Subject SATURN T.

Subject SATURN T

Following faults traced on the
two units sent in for reparation

FUSES & TEST POINTS, ADE

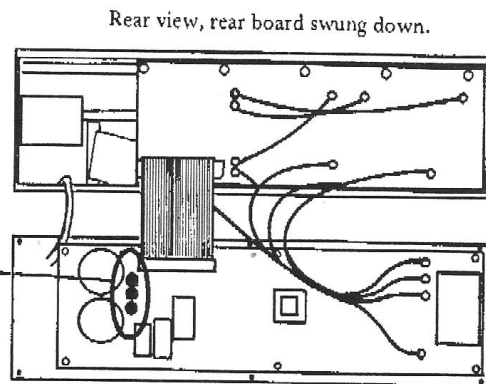
Pls. check the fuses on the
units in Eritrea.

I am sure that blown fuses
is the problem.

Mn. Testpage!
Pls. check the fuses
